# HISTORIC AND DESIGN REVIEW COMMISSION

**HDRC CASE NO:** 2021-175  
**ADDRESS:** 414 BARRERA  
**LEGAL DESCRIPTION:** NCB 926 (EIM LAVACA), BLOCK 4 LOT 33  
**ZONING:** IDZ,H  
**CITY COUNCIL DIST.:** 1  
**DISTRICT:** Lavaca Historic District  
**APPLICANT:** Nathan Manfred/French & Michigan  
**OWNER:** EIM LV LLC  
**TYPE OF WORK:** Installation of front porch railings  
**APPLICATION RECEIVED:** April 05, 2021  
**60-DAY REVIEW:** Not applicable due to City Council Emergency Orders  
**CASE MANAGER:** Stephanie Phillips

The applicant is requesting a Certificate of Appropriateness to install a wood railing around the existing front porch. The railing will be wood with top and bottom rail and square wood pickets.

414 Barrera - Front Facade

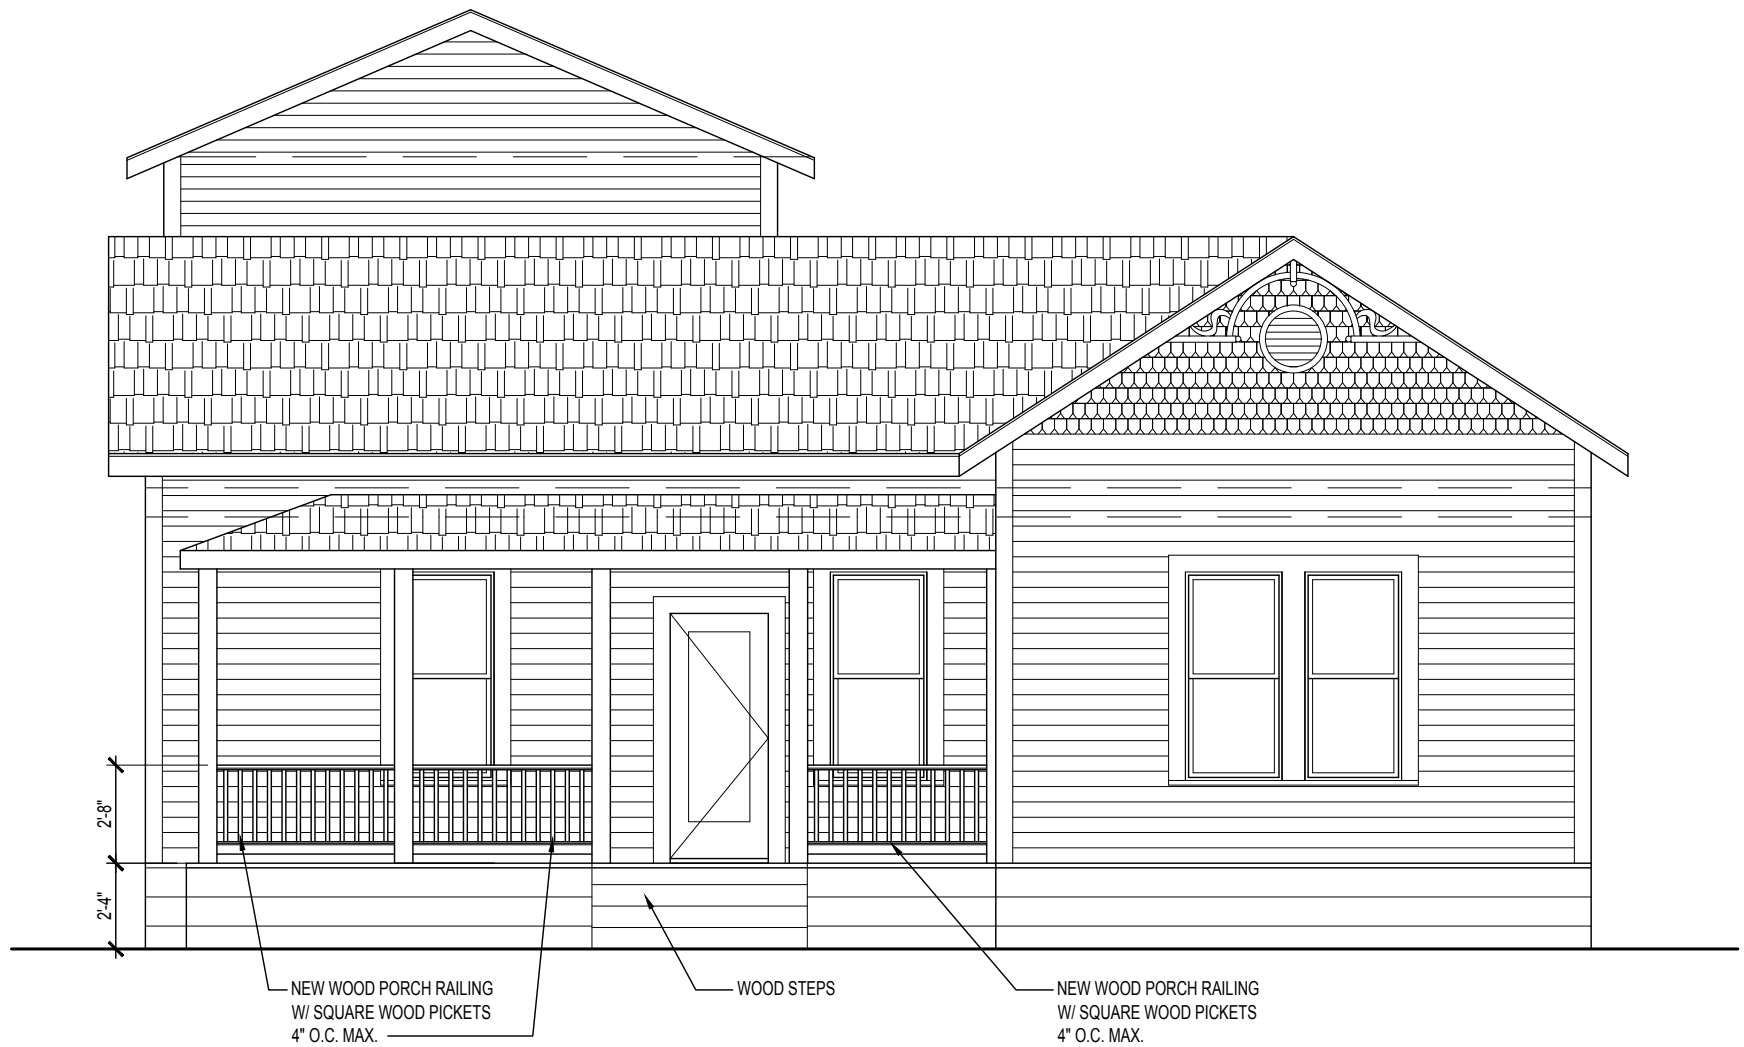
- a. The primary structure at 414 Barrera is a 1-story residential structure constructed circa 1910 in the Folk Victorian style. The structure features woodlap siding, one over one wood windows, a cross gable roof configuration with a front gable, and an asymmetrical front porch. The structure is contributing to the Lavaca Historic District.
- b. **RAILING** – The applicant has proposed to add a railing to the front porch. Based on the submitted documentation, the railing will be wood and will feature a simple baluster and rail design. According to the Historic Design Guidelines, porch elements should be reconstructed in-kind. If no such evidence exists, the design should be based on the architectural style of the building and historic patterns. Staff finds the proposed railing to be appropriate.

Staff recommends approval based on findings a and b.
